Access Compliance Report Public Rights-of-Way (Curb Ramps)

Main Street: N/A	Cross Street: SKLAR_ST	Location: N
------------------	------------------------	-------------

ADA ID: RPRK211103124328	Ramp Type: Type 4 - Parallel	Initial Pass/Fail: Fail	Overall Compliance: No	Severity Score: 2
--------------------------	------------------------------	-------------------------	------------------------	-------------------

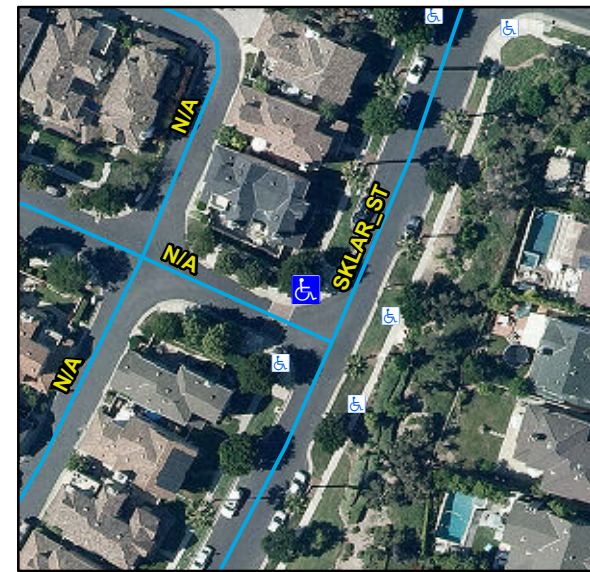
R304.2.2, R204.3, R304.5.3, STD 1115

Compliance	Description	Data	Compliance	Description	Data
N/A	Ramp Length LT (in)	138	N/A	Ramp Length RT (in)	123
Yes	Ramp Width LT (in)	89	Yes	Ramp Width RT (in)	89
Yes	Ramp Run Slope LT (%)	3.1	Yes	Ramp Run Slope RT (%)	7.6
No	Ramp Cross Slope LT (%)	2.5	Yes	Ramp Cross Slope RT (%)	1.2
N/A	Landing Present	N/A	N/A	DWS Provided	N/A
N/A	Landing Length (in)	N/A	N/A	DWS Contrast	N/A
N/A	Landing Width (in)	N/A	N/A	DWS Length (in)	N/A
N/A	Landing Run Slope (%)	N/A	N/A	DWS Full Width	N/A
N/A	Landing Cross Slope (%)	N/A		DWS Offset Type	N/A
N/A	Landing Movement Obstructed?	N/A	N/A	DWS Offset Left (in)	N/A
	Landing Movement Type	N/A	N/A	DWS Offset Right (in)	N/A
N/A	Landing Shared	N/A			
N/A	Clear Space	Yes			
N/A	Clear Space To Crosswalk (in)	N/A			
N/A	Marked Crosswalk 1	No	N/A	Marked Crosswalk 2	No
	Crossing 1 Direction	SW		Crossing 2 Direction	SE
	Marked Crosswalk 1 Width (in)	N/A		Marked Crosswalk 2 Width (in)	N/A

N/A	Ramp Inside Crosswalk 1	N/A	N/A	Ramp Inside Crosswalk 2	N/A
	Crossing 1 Slope (%)	1.7		Crossing 2 Slope (%)	2.4
	Crossing 1 Cross Slope (%)	1.3		Crossing 2 Cross Slope (%)	1.1
N/A	Gutter Ponding	N/A	No	Curb Slope	11.1
Yes	Gutter Lip Height (in)	0		Road Run Slope (%)	0.8
N/A	Gutter Run Slope (%)	N/A		Road Cross Slope (%)	1.4
N/A	Gutter Cross Slope (%)	N/A	No	Perpendicular Joint Present	No
Yes	Overall Surface Condition	Acceptable			
	Cross Gutter Present?	No		Spandrel Present?	No
	Replace Cross Gutter?	N/A		Replace Spandrel?	N/A

Remove & Replace Curb Ramp With Two New Directional Ramps or Equivalent.
